MEMORANDUM

TO: John Taylor, Planning Manager
Town of Kiawah Island, South Carolina

FROM: Lucas Hernandez, Project Environmental Scientist
Weston & Sampson Engineers, Inc.

SUBJECT: Peer Review: Ocean Pines (Parcel ID: 207-05-00-118)
Application for Multifamily Residential Development

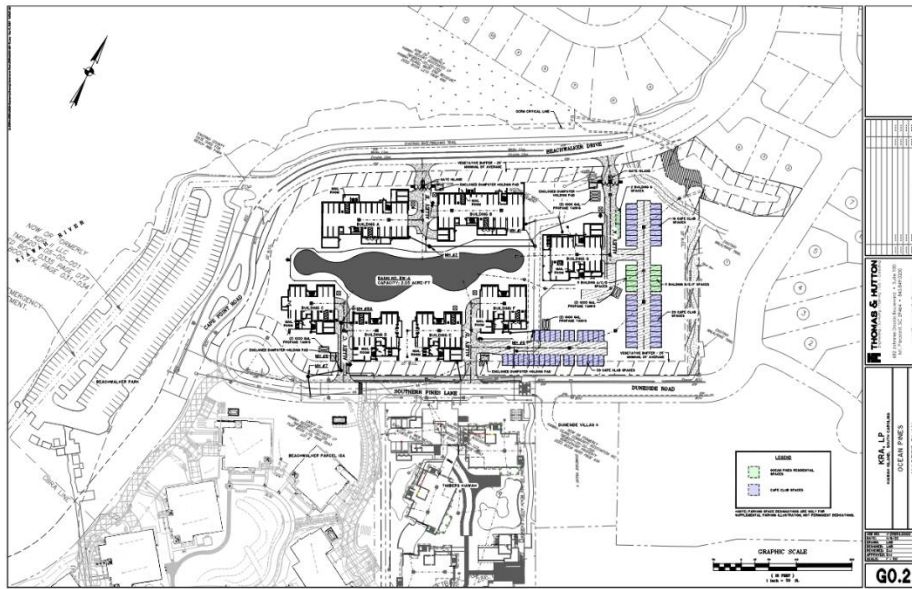
Note 4 of Exhibit 13.4 states “no ‘head-in’ parking shall be permitted unless a variance is approved by the Board of Zoning & Appeals; each off-street parking space shall be accessed from a private drive and not from a KICA or other dedicated street.” Of the 20 spaces shown on Sheet G0.2 of the Cape Point PEBA plans, two spaces appear to be parallel to the drive and 18 spaces appear to be head-in spaces. We recommend that the Town make a determination as to whether head-in parking will be approved on this drive.
